**PLANNED UNIT DEVELOPMENT
& SUBDIVISION STAFF REPORT**

Date: March 5, 2015

<u>DEVELOPMENT NAME</u>	Travel Quarters Subdivision, Resubdivision of Lots A & B
<u>SUBDIVISION NAME</u>	Travel Quarters Subdivision, Resubdivision of Lots A & B
<u>LOCATION</u>	(West side of Michigan Avenue, extending to the Northwest corner of Raven Drive and Cardinal Drive East)
<u>CITY COUNCIL DISTRICT</u>	District 3
<u>AREA OF PROPERTY</u>	2 Lots / 3.77 ± Acres
<u>CONTEMPLATED USE</u>	Planned Unit Development Approval to allow shared access between two building sites, and Subdivision approval to create 2 lots.
<u>TIME SCHEDULE FOR DEVELOPMENT</u>	None given.

SITE PLAN

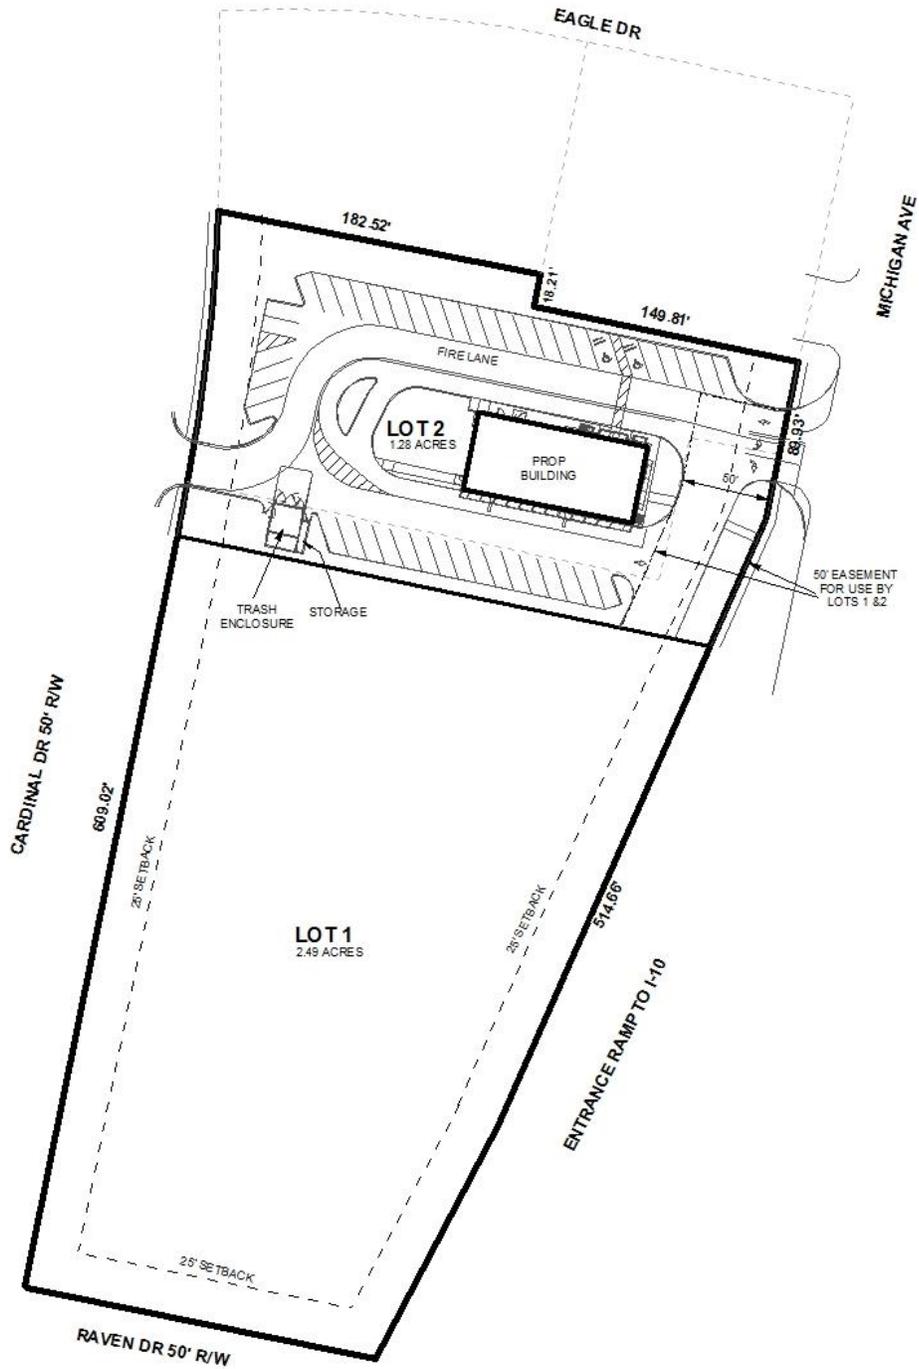
Although the site plan does not depict tree and landscaping, a "Landscape Data" table is depicted on the site plan. Based on the calculations provided, it appears that the landscaping requirements will be met. However, there is no information regarding the total number of proposed trees that will be provided. The site plan should be revised to depict full compliance with Sections 64-5.C.2.c and 64-4.E.3.a. of the Zoning Ordinance.

The proposed use of Lot 2 is a restaurant which appears to have one drive lane, 2 order stations, and 2 service windows. Section 64-4.F.2 of the Zoning Ordinance addresses design standards for drive-thru business. All queuing spaces must be 9 feet wide by 20 feet long. The drive-through lane must provide a minimum of 3 queuing spaces from the street right-of-way to the service window. The restaurant service windows are shown on the site plan and although it appears that adequate space may be provided the site plan does not depict queuing spaces. A revised site plan illustrating the location of the service windows and queuing spaces will be required.

A dumpster is depicted on the site plan and does appear to be enclosed on all three sides. However, there is no indication that the dumpster will be connected to sanitary sewer. Site plans submitted for permitting should be revised to indicate if the dumpsters will be connected to sanitary sewer. It should also be noted, when submitting for a building permit, detailed plans illustrating the dumpster within a wooden or brick enclosure of at least 6 feet, but not to exceed 8 feet, in height will be required. A note should be placed on the site plan stating all new dumpsters will comply with Section 64-4.D.9. of the Zoning Ordinance.

A sidewalk is depicted on the site plan along Michigan Avenue. No sidewalk is depicted along Cardinal Drive. The site plan should be revised to also indicate a sidewalk along Cardinal Drive, or a Sidewalk Waiver request should be submitted.

It should be pointed out that the southeast corner of Lot 1 appears to have a dashed area on the plan which appears to possibly be an easement. However, the area is not labeled and no information has been provided; thus the dashed area should be removed from the site plan.

- 1) placement of a note on the site plan stating no structures shall be placed in any easements;
- 2) retention of the lot sizes in square feet and acres on the site plan;

- 3) retention of the 25' minimum building setback lines on the site plan;
- 4) placement of a note on the site plan stating Lot 2 is limited to one curb-cut to Michigan Avenue and one curb-cut to Cardinal Drive with the size, design and location to be approved by Traffic Engineering, and in conformance with AASHTO standards;

- 5) placement of a note on the site plan stating that Lot 1 is denied access to Cardinal Drive and Raven Drive at this time until future development of the site;

- 6) retention of the labeling of the right-of-way width of Cardinal Drive and Raven Drive;
- 7) labeling of the right-of-way width of Michigan Avenue;
- 8) retention of the landscaping calculations provided on the site plan;

- 9) compliance with Sections 64-5.C.2.c and 64-4.E.3.a of the Zoning Ordinance;
- 10) revise the site plan to illustrate the location of the service windows and queuing spaces for the proposed drive-through(s);

- 11) placement of a note on the site plan stating the proposed dumpster will be enclosed on all three sides and connected to sanitary sewer;
- 12) placement of a note on the site plan stating all new dumpsters must to comply with Sections 64-4.D.9 of the Zoning Ordinance;

- 13) placement of a note on the site plan stating at the time of development of Lot 1, a vegetative buffer will be required where the site is adjacent to residentially zoned property;

- 14) removal of the dashed area located at southeast corner of Lot 1;
- 15) revision of the site plan to depict a sidewalk along Cardinal Drive or the submission of a sidewalk waiver;
